STAFF RECOMMENDATION
200 Broadway
September 18, 2019

Application: New Construction—Addition; Alterations
District: Broadway Historic Preservation Zoning Overlay
Council District: 19
Base Zoning: DTC
Map and Parcel Number: 09306204400
Applicant: Tyler Thayer
Project Lead: Melissa Baldock, melissa.baldock@nashville.gov

Description of Project: Application is to construct a rooftop addition, to reconstruct oriel windows on the Broadway facade, add window openings to the rear, add a cornice to the 2nd Avenue façade, replace non-historic windows, and alter the storefront. Although signage location is shown on the drawings, any signature will need to have a separate review and preservation permit once the final details, including materials, size, illumination, and placement are known.

Figure 1. Broadway façade of 200 Broadway.

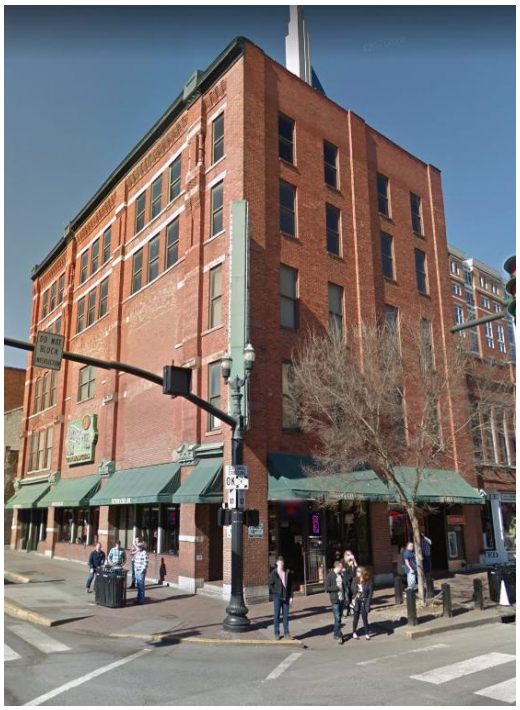
Background: The National Register report for the Broadway Historic District describes 200 Broadway as "1884. Victorian eclectic commercial building, five stories, brick and terra cotta, pressed metal cornice, and largely intact cast iron first story piers" (Figure 1). While much of the building remains intact, it has experienced several changes over the years. C. 1938, 2nd Avenue was widened, and the 2nd Avenue façade and two window bays of the Broadway façade were demolished (Figures 2, 3). The 2nd Avenue façade largely dates to this time. Historic photos (dates unknown) show both the original size and 2nd Avenue façade of the building, as well as oriel windows on the Broadway façade that have since been removed (Figures 4,5). The existing windows are not historic; neither are the storefront windows and bulkhead. The cast iron storefront piers remain.

Figure 6. The rear façade of 200 Broadway will have new window openings.

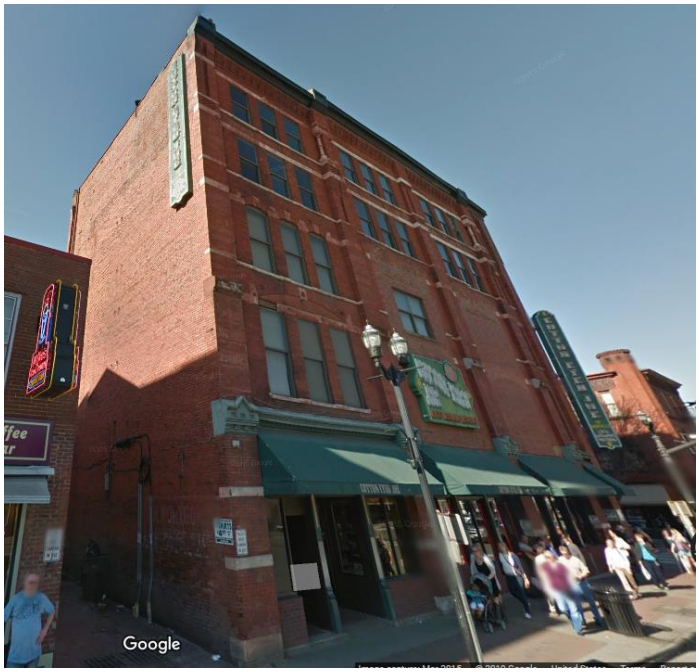
On the rear façade, the applicant intends to add eight new window openings, two per floor on the 2nd through 5th floors, and a door opening at the first floor (Figure 6). This façade is visible because of an alley and because 200 Broadway is three stories taller than its neighbor to the north. Staff finds that the new openings are appropriate because they are on a non-street-facing façade, and have a simple design.

Staff finds that the alterations to the windows meet Section II.H. of the design guidelines.

Figures 7, 8, 9 are the historic cast iron posts that remain and should be retained.

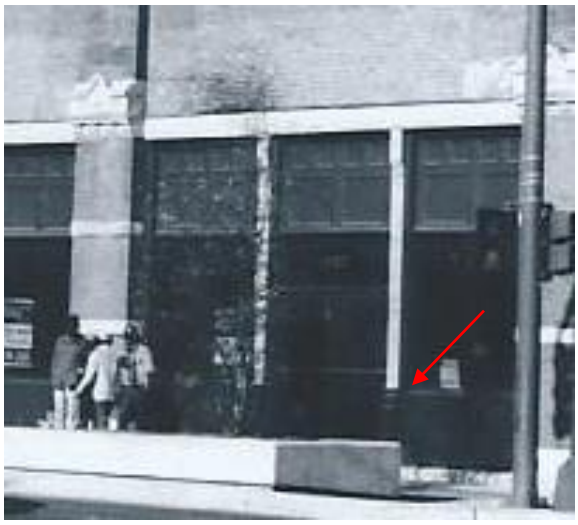
Alterations – Storefront. The applicant intends to alter the storefront. Although much of the storefront is not original, along Broadway, the cast iron storefront posts remain. Staff finds that these are a significant feature of the storefront and recommends that they remain and be incorporated into the new storefront design (Figures 7, 8, 9).

The materials for the storefront will be cast stone and aluminum clad. Staff recommends approval of a stone sample and the final storefront window and door selections. Staff finds that the proposed canopy does not obscure architectural details and will be an appropriate material- steel. Staff will want to approve the final dimensions, design, location, material, and illumination of any canopy sign when those details are known.
